ASSESSMENT OF FUEL PERFORMANCE FROM POST-IRRADIATION EXAMINATION AND SAFETY TESTING

Responses to RAI #5 for Topical Report EPRI-AR-1(NP)

Figure 1. Radar plot of the ranges for key irradiation parameters for AGR-1 and AGR-2 fuel.

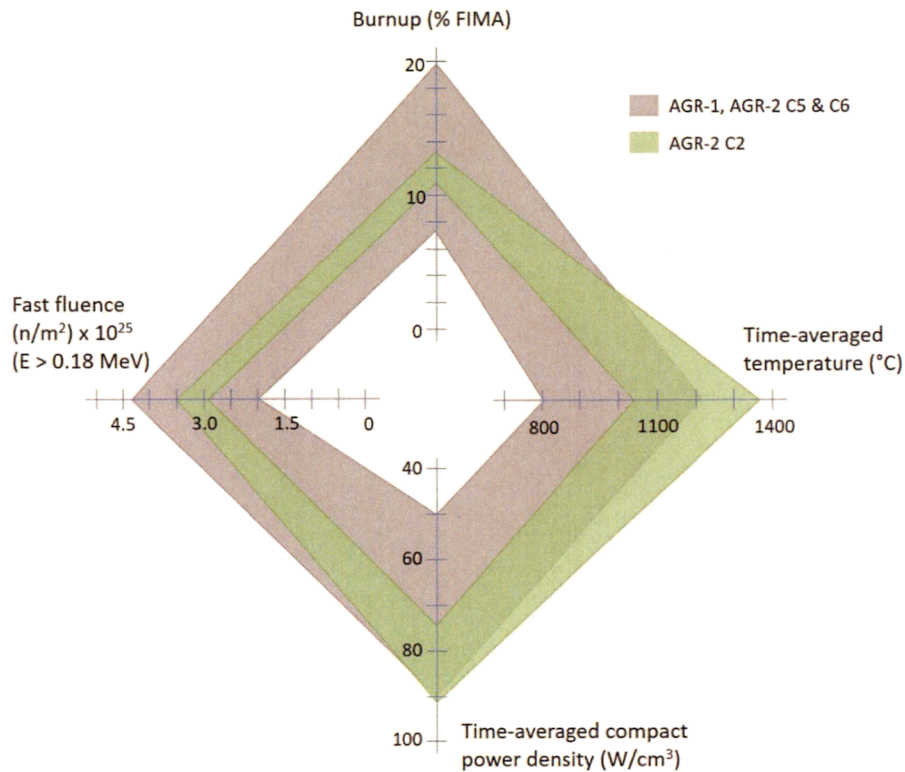
Conclusion 1 of the topical report (TR) states that "testing of UCO TRISO-coated fuel particles in AGR-1 and AGR-2 constitutes a performance demonstration of these particle designs over a range of normal operating and off-normal accident conditions." Discussions under the conclusion reference a compact-averaged burnup of 7.3-19.6% fissions per initial metal atom (FIMA) and time averaged maximum temperatures of 1069-1360°C. Are there other relevant performance parameters that bound the data set, such as those referenced in Figure 4-6 (packing fraction, fluence, power density)? Based on the discussion in the report, it appears some of these parameters could influence particle performance, but these values are not provided as bounds for the "range of normal operating and off-normal accident conditions". Provide context for what constitutes a "range of normal operating and off-normal accident conditions" (e.g. reference a table), or provide a justification for why burnup and time averaged temperature are sufficient.

There are additional relevant performance parameters associated with the data. The key parameters for tristructural isotropic (TRISO) fuel performance are burnup, temperature, fast neutron fluence, and power. The ranges of values have been summarized in Table 1 and Figure 1 below. Additional details on these parameters for the two irradiation experiments were provided in Section 6 of the report, including time-dependent variation throughout the irradiation.

Material from the above response, including Table 1 and Figure 1, will be added to Section 6.6 (Broader Comparisons of Key Service Conditions). In addition, the supporting discussion under Conclusion 1 in Section 8 (Summary/Conclusions) will be modified.
